RE: Bay Side Bowl 58 Alder St.

Re: Bowl Portland

## FIELD REPORT

Project Name: **Bowl Portland**  
Project #: **9065**  
Date at Site: **March 24, 2010**  
Report Date: **April 20, 2010**  
Present: **Tony Dumais**

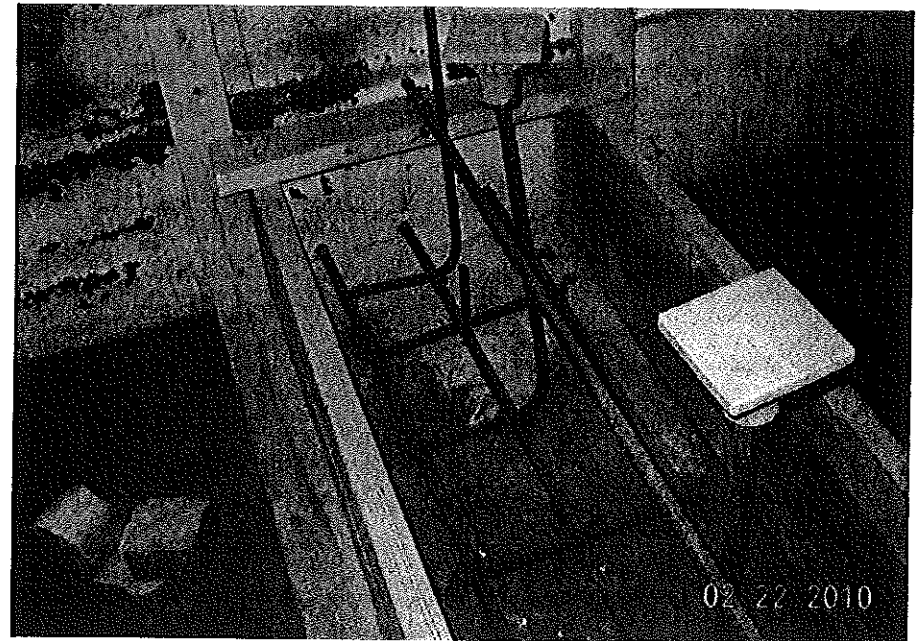
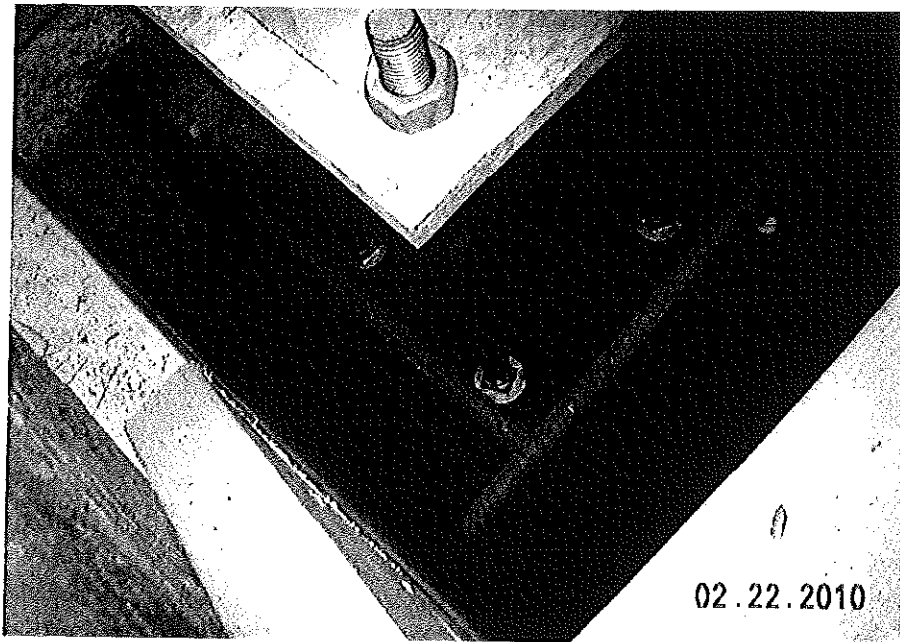
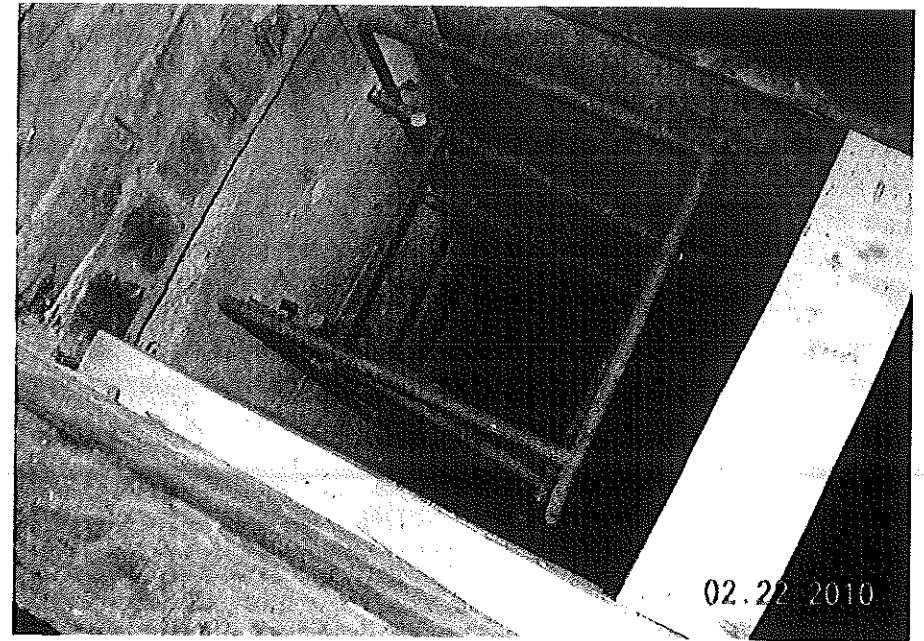
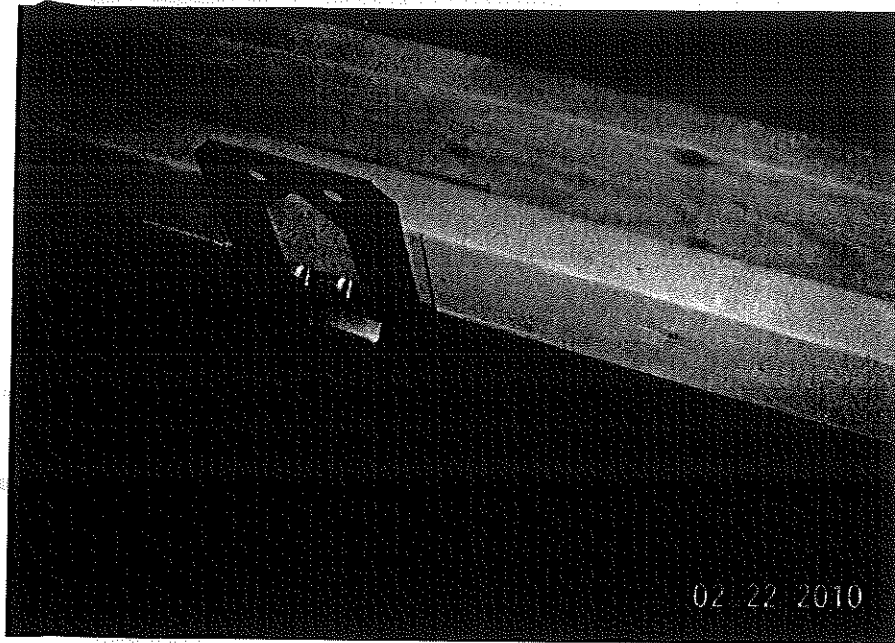
Non-Conformance Item Description: See notes.  
 Action Taken by SWCE: Notified Bob with Zachau Construction. SWCE recommended that Zachau contact the engineer for further direction.  
 Persons Notified: Bob with Zachau Construction

SWCE observed following non-conformance items: rebar mat at pier footings in kitchen extended beyond wood form and into earth or native subgrade. The tie bars at Brace Bay piers were fabricated onsite by tying 4 pieces of cut rebar together. At more than one location this rebar was embedded into existing walls in-place of horizontal "U" bars. Horizontal "U" hook bars at pier were not embedded 8" into existing foundation wall. These horizontal "U" hook bars were installed vertically at pier (See photos). These items were discussed with Zachau Construction. SWCE recommended Zachau contact Casco Bay Engineering for further direction. Zachau Construction proceeded with construction.

Picture 4

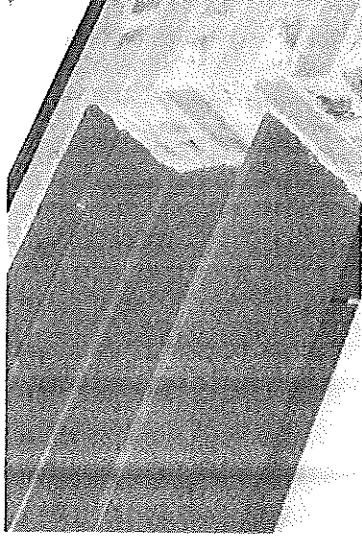
4. The new LVL beams located below the proposed cooler appear to have been installed correctly with proper LVL nailers, through bolts, and Simpson hangers (See Picture 3). However, the contractor shall verify that the area that was reinforced extends the full area where the cooler will be located on the second floor.

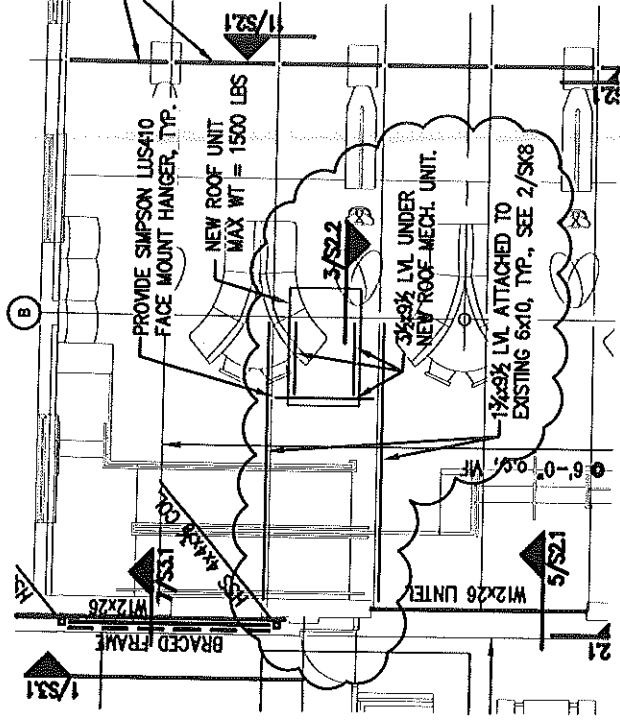
DRAWING DETAIL S3.1 (2)  
HSS 4x4 BRACE FIELD CONNECTIONS 1/4 x 4

DRAWING DETAIL S3.1 (7) & SK6  
PLATE STITCH WELDS 3-12 x 1/4

> BRACE CONNECTIONS REVEAL 5/16" x 4" FIELD WELDS  
@ TOP PLATE w/ MISSING INSIDE LOWER WELD. \*  
BOTTOM REVEALS ALL (4) FIELD WELDS MEET DRG. REQ.

> PLATE STITCH WELDS COMPLY WITH DRG. REQ.

\* Eng. EVAL In-Progress and  
Determined Acceptable @ 09:30  
ON 6/2/10

**SK8**

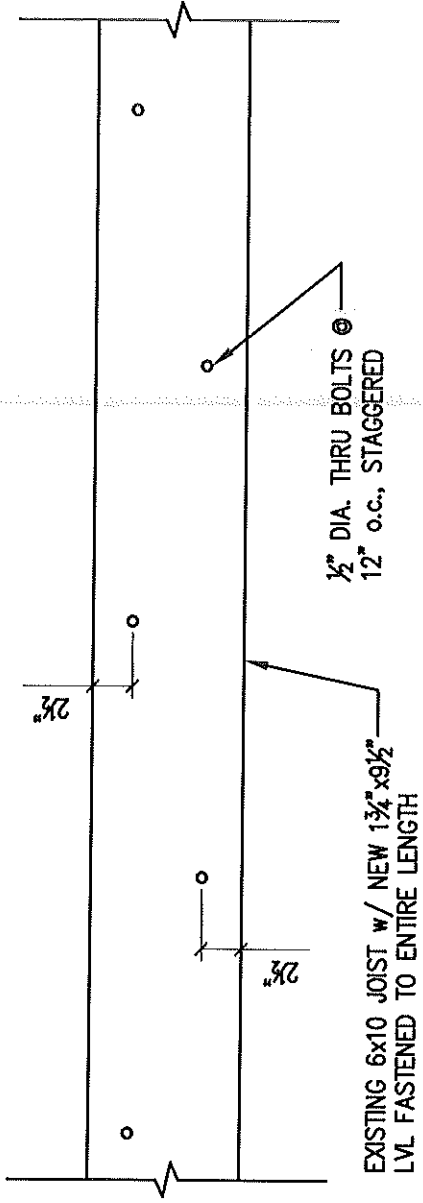
Casco Bay Engineering analyzed the existing roof for the new mechanical unit located approximately at gridlines 1.6 & B over the bowling alley. The unit has a maximum weight of 1500 lbs and required additional roof members as shown on drawing SK8.
